## Response to Comments

PROPOSED TEMPORARY OPEN STORAGE AND WAREHOUSE OF CONSTRUCTION MACHINERIES FOR A PERIOD OF THREE YEARS IN “AGRICULTURE” ZONE

LOT 369 OF D.D. 87, HUNG LUNG HANG, NEW TERRITORIES

Figure 1 Revised Drainage Plan

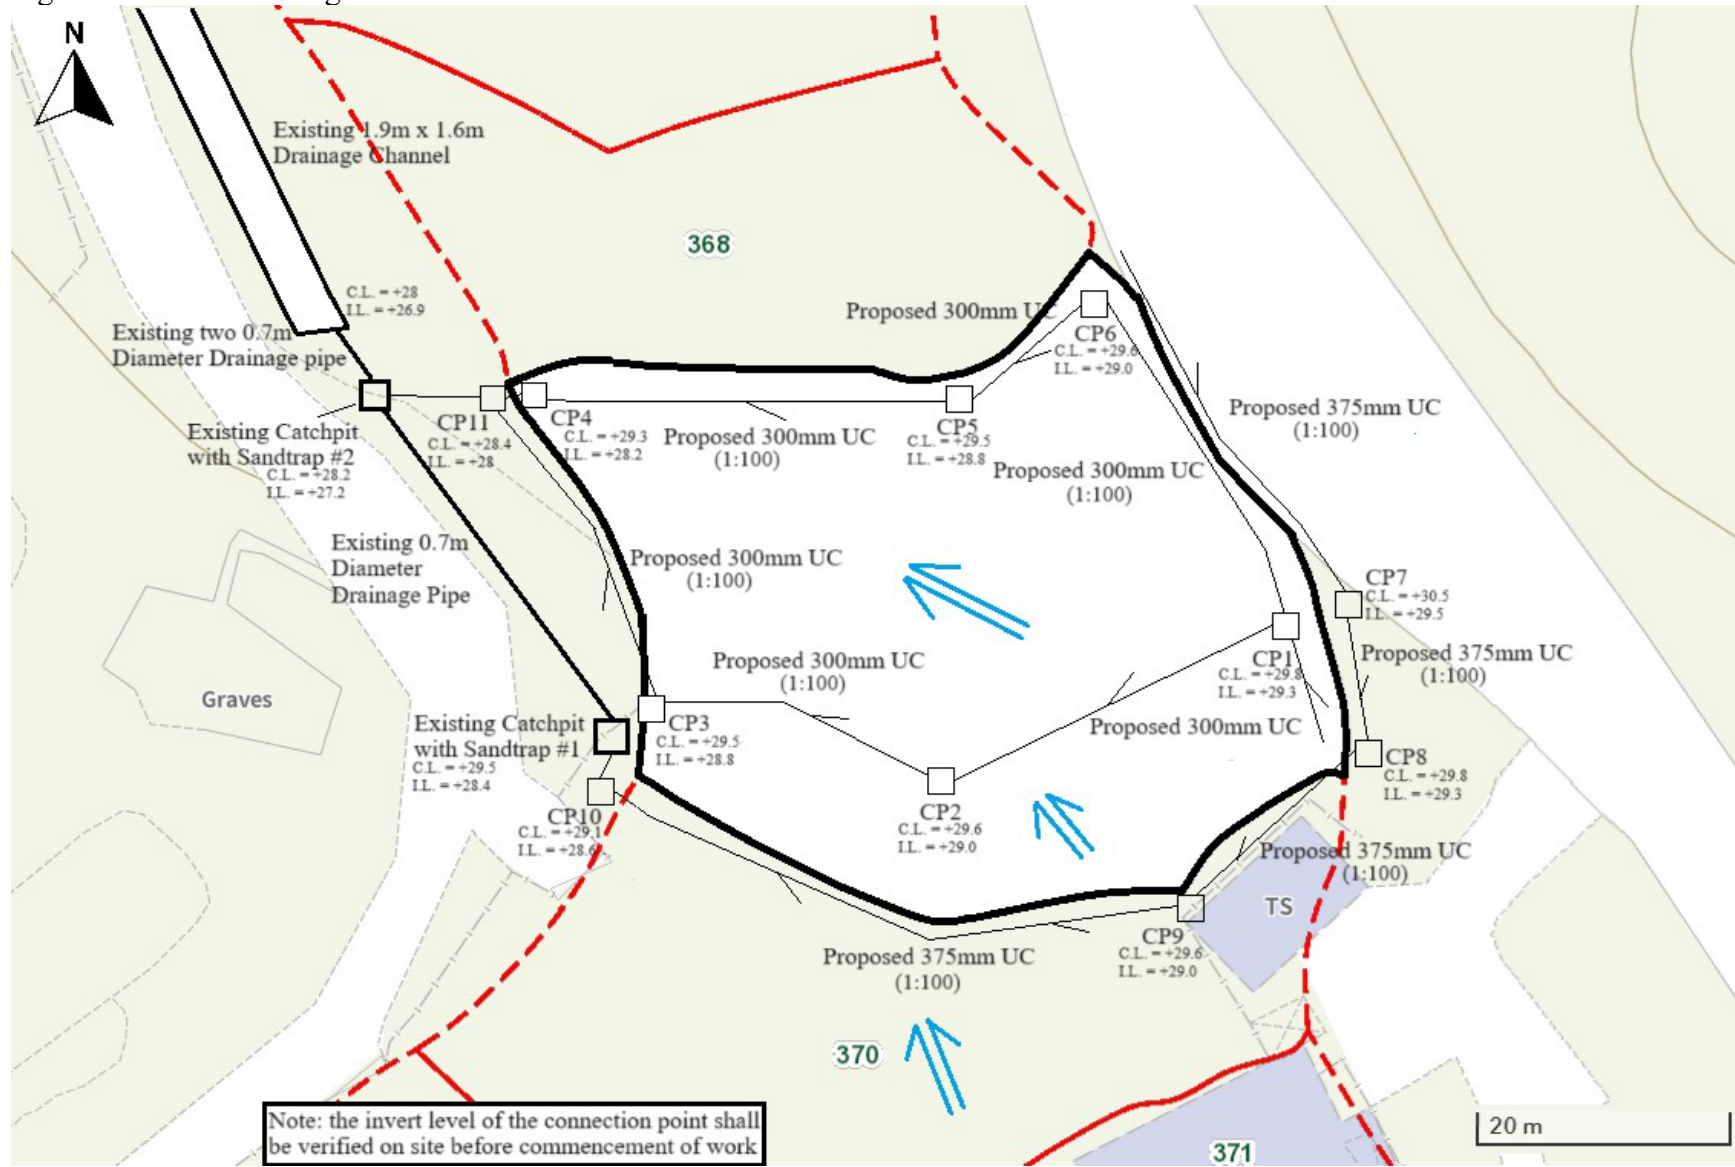
Departmental Comments	Applicant’s Response
<p><u>Comments from Drainage Services Department</u></p> <p>1. Please check and advise if the existing 0.7m diameter pipe has adequate capacity and in satisfactory condition to cater for the additional discharge from the site and associated external catchment area. Also, please advise the existing upstream catchment area of the existing 0.7m dia. Drainage pipe</p>	<p>Please find attached calculations that shows the existing 0.7m diameter pipe has adequate capacity and in satisfactory condition to cater to the existing upstream catchment area as well as the additional discharge from the site and associated external catchment area.</p>
<p>2. Please indicate the invert levels and catchpit types in the drainage proposal. Especially please specify the catchpits with sand trap</p>	<p>Please find below revised Drainage plan with Invert levels and catchpit types, Figure 1.</p>
